# **Addendum to Appendix D**

## **Technical Alignment Report**

*Prepared by*  
Alaska Department of Transportation and Public Facilities  
6860 Glacier Highway  
Juneau, Alaska 99801-7999

This addendum outlines changes to the design criteria, updates the alignment discussion where changes have occurred, provides updated bridge summaries, provides updated plan and profile sheets where changes have occurred, updates ferry terminal layouts and cost estimates, updates the Engineer's Estimate, and provides an errata sheet for the original technical report.

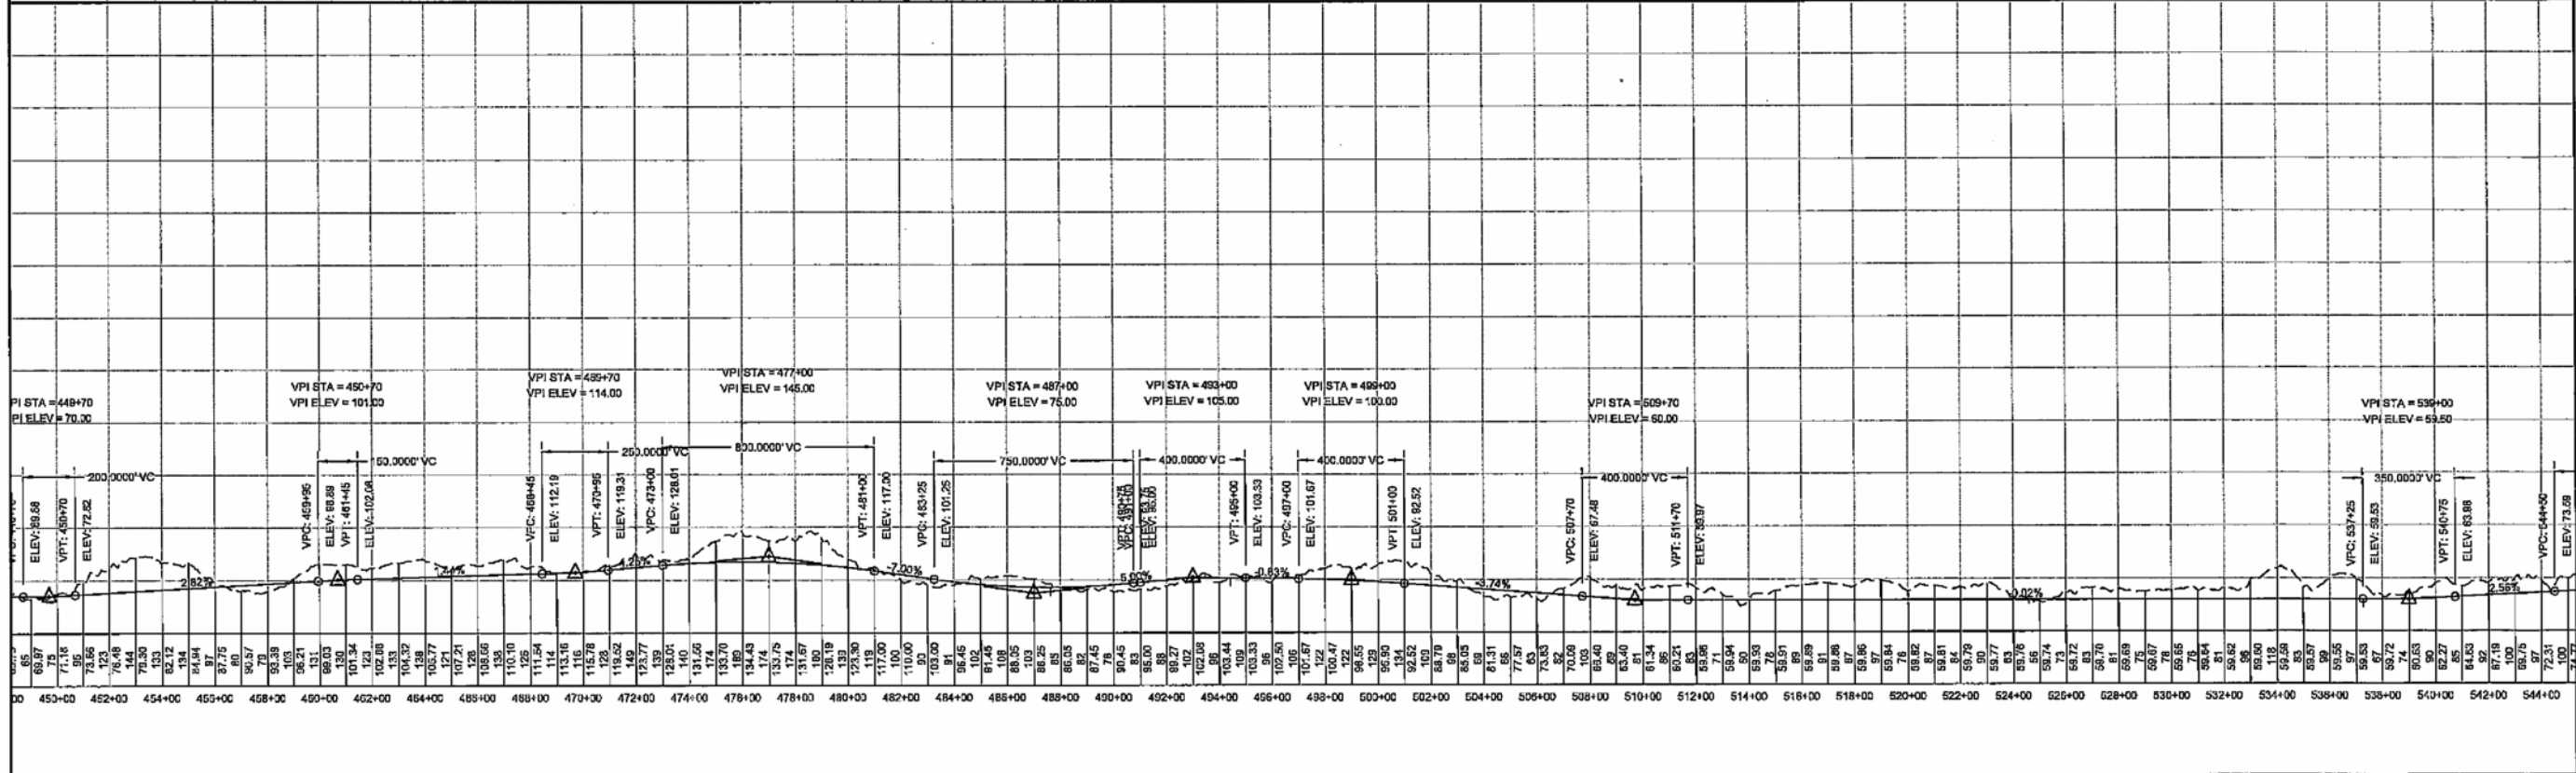
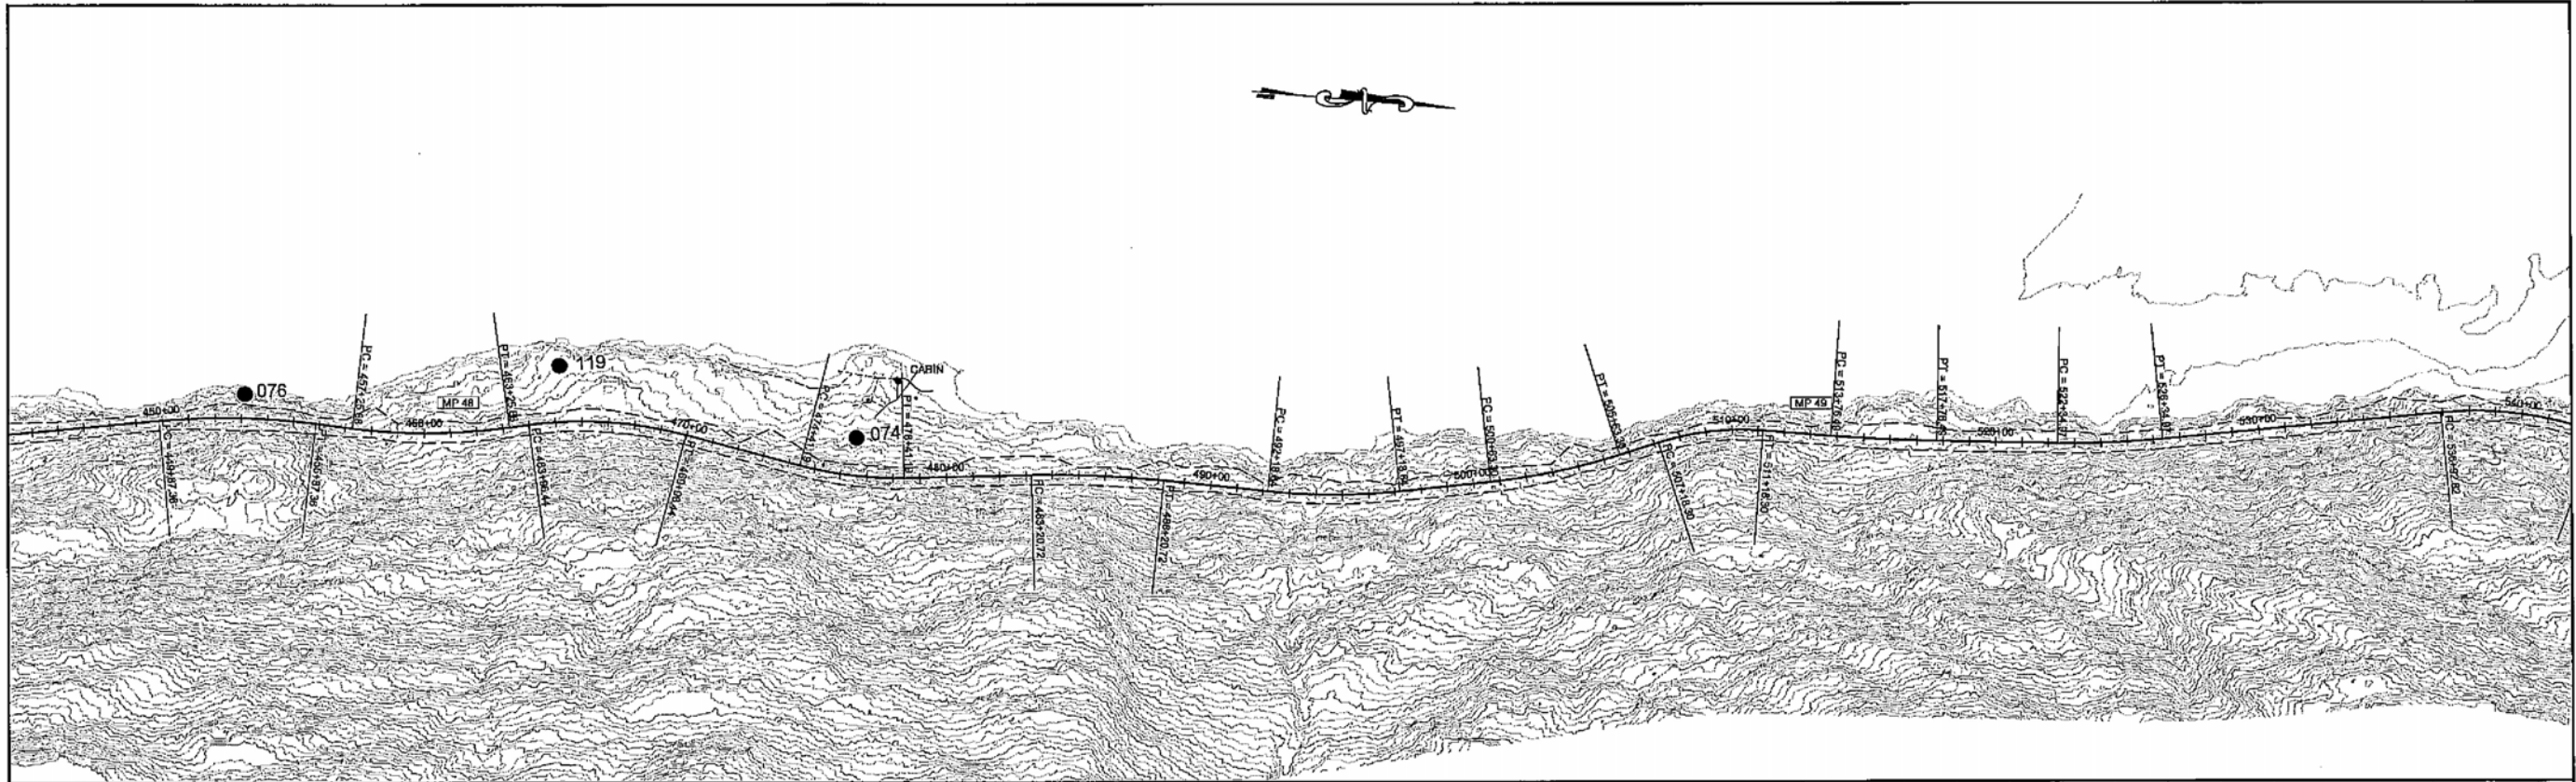
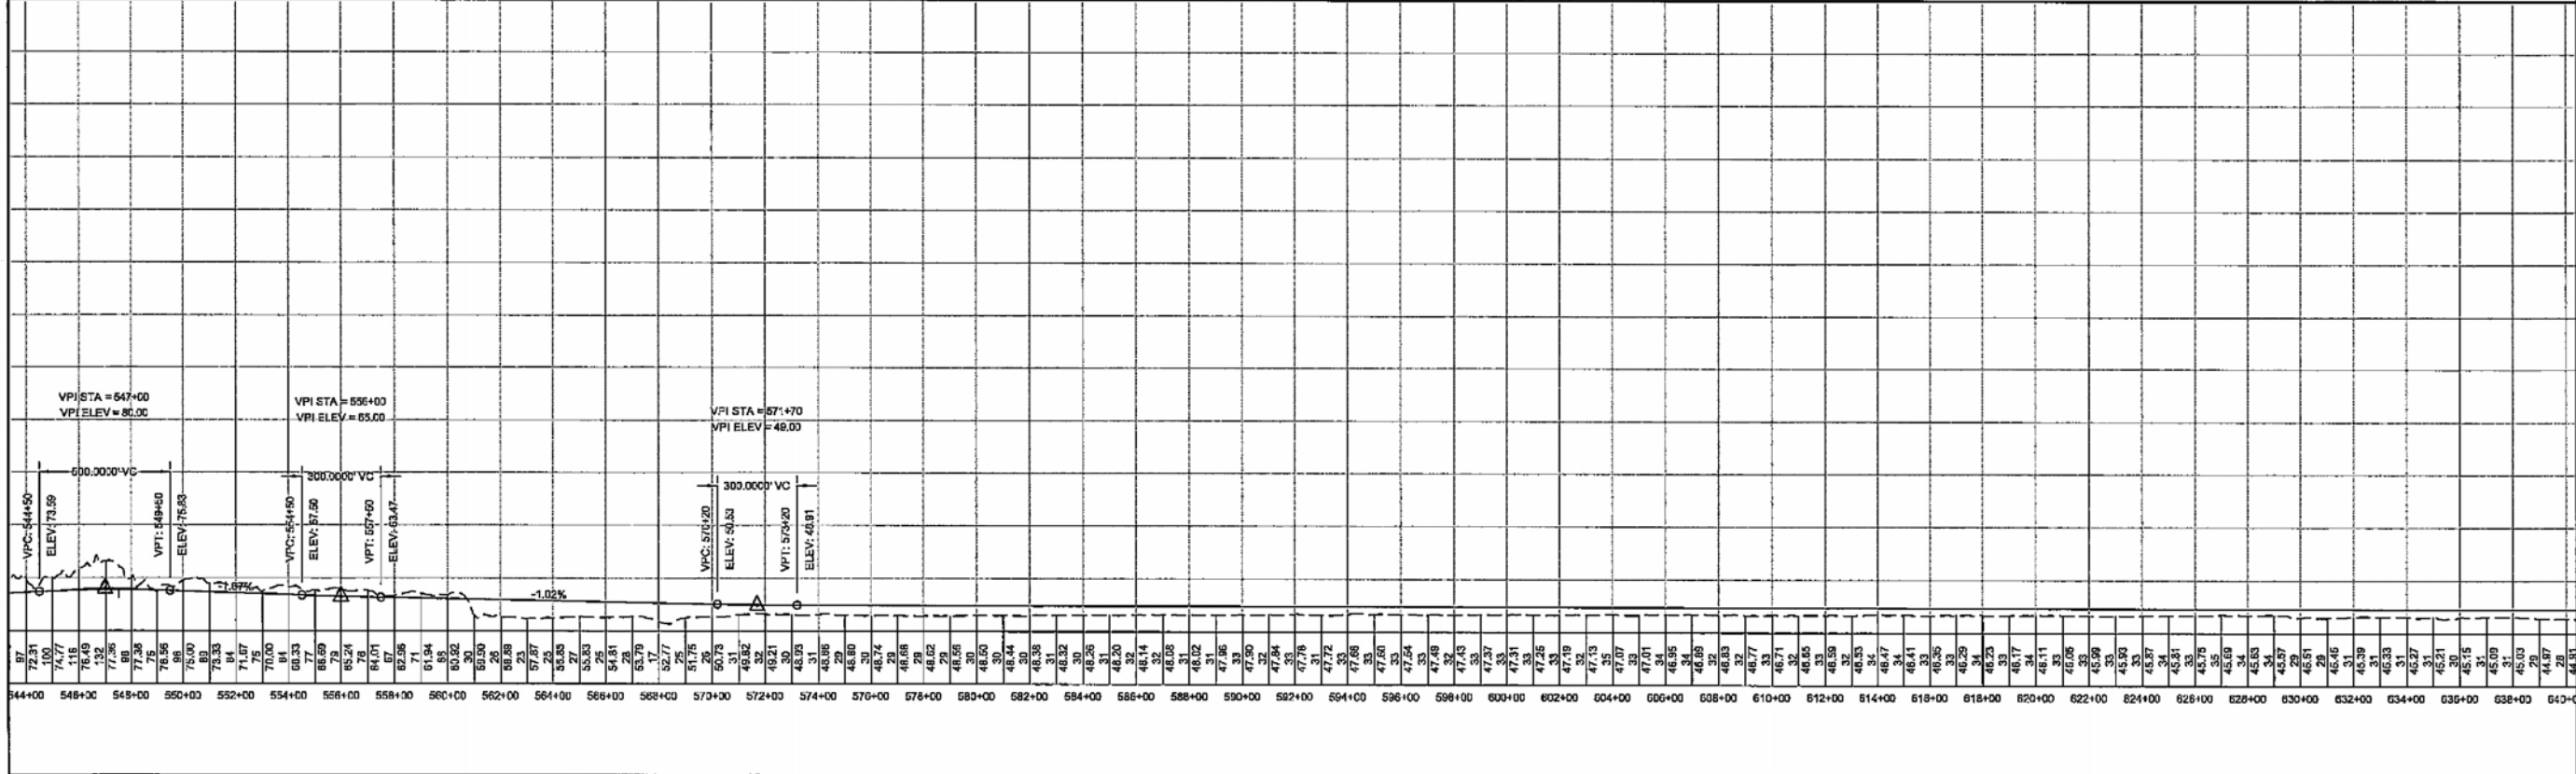
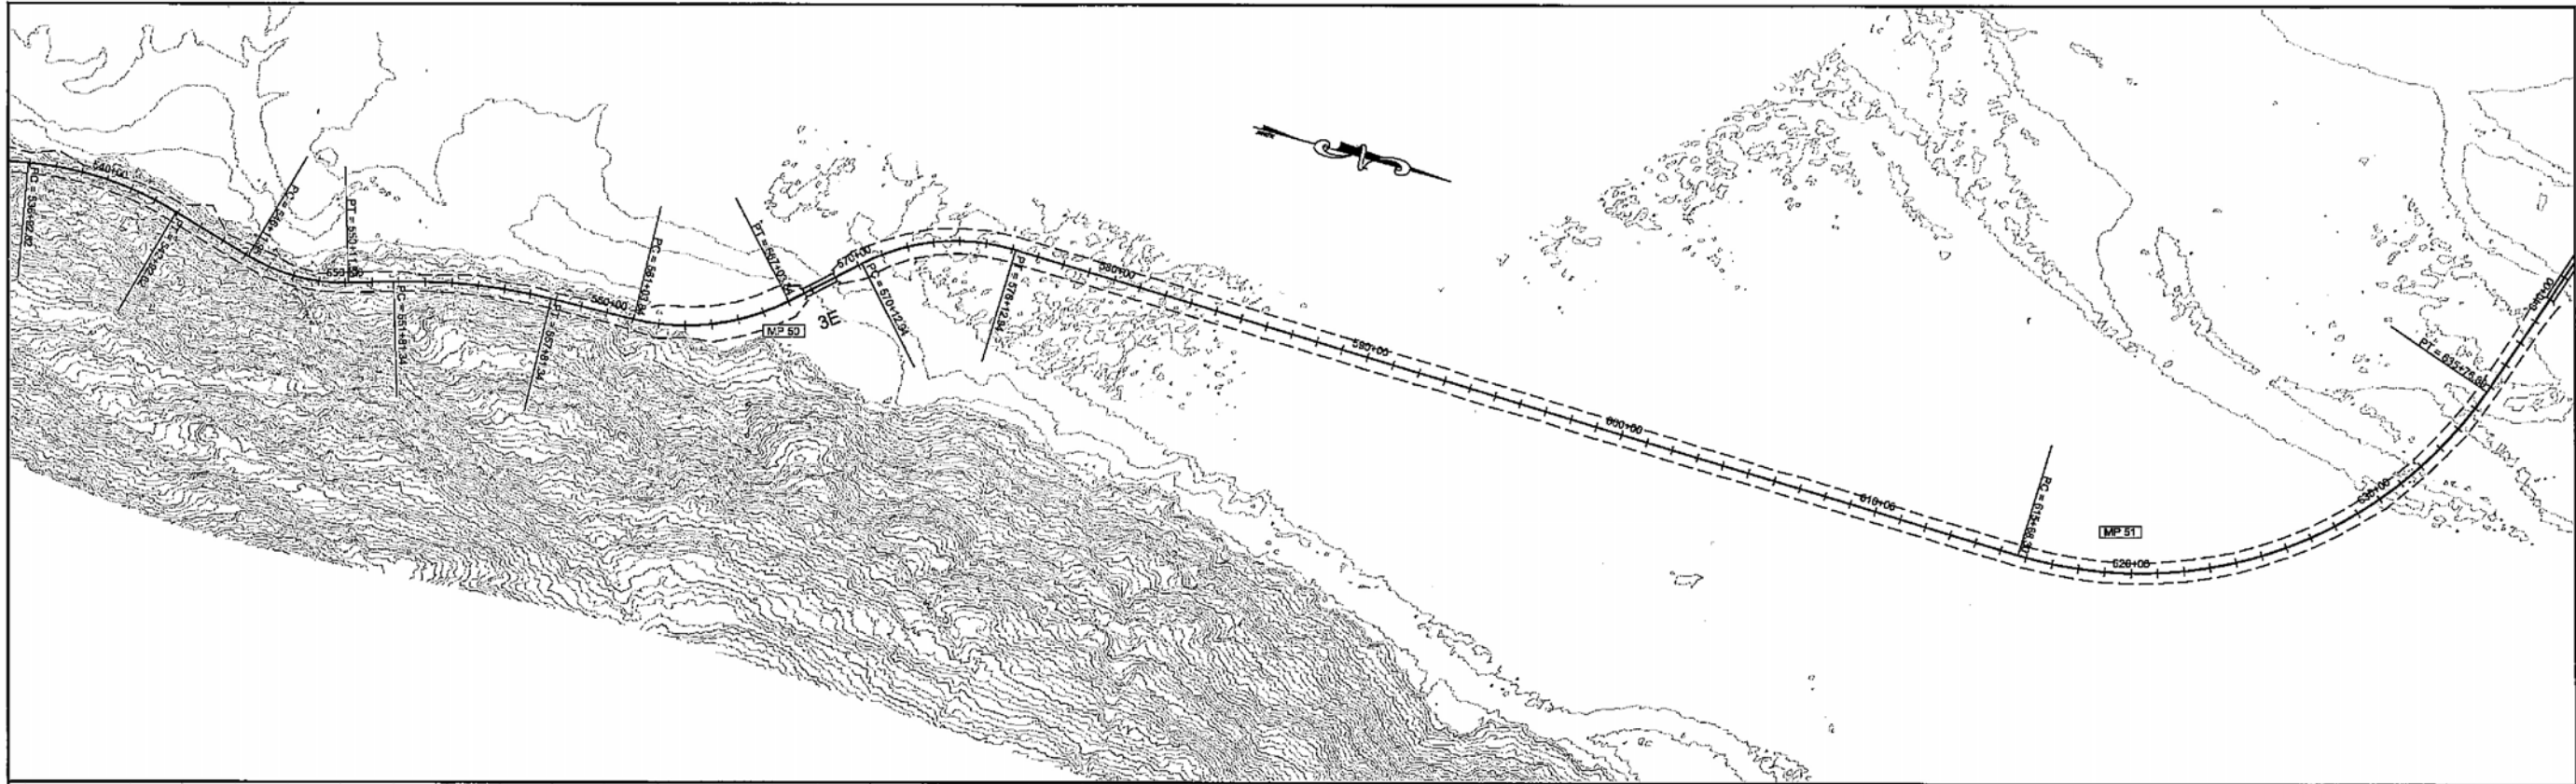
**Station 64+75 (MP 40.5) to Station 561+00 (MP 49.9) - Echo Cove to Berners Bay Crossing** – This segment was shortened to 9.4 miles due to alignment revisions on the Berners Bay Crossing segment.

The alignment was shifted uphill between Station 64+75 and Station 207+00 to straddle the Goldbelt Cascade Point Road alignment footprint. Additional adjustments to the alignment were made between Station 207+00 and Station 410+00 to avoid emergent wetlands and minimize impacts to lower value wetlands, as well as to provide a more perpendicular bridge crossing over Sawmill Creek. The nature of the terrain remains unchanged.

From Station 477+00 forward, the alignment was optimized by making minor downhill shifts where possible, and by following the curvature of the terrain more closely. This downhill adjustment was required at the end of the segment to provide a suitable approach to the first bridge on the Berners Bay Crossing Segment.

By entering the timbered uplands at Station 561+00, 4,100 feet of steep sidehill cuts were eliminated. This reduced the rock excavation quantities and removed the visual impact of large cut backslopes. This new alignment eliminates potential water quality impacts that an uphill alignment could have to the stream in this area.

Revised Plan and Profile Sheets for this segment (Sheets 2-8) are included in Attachment A.
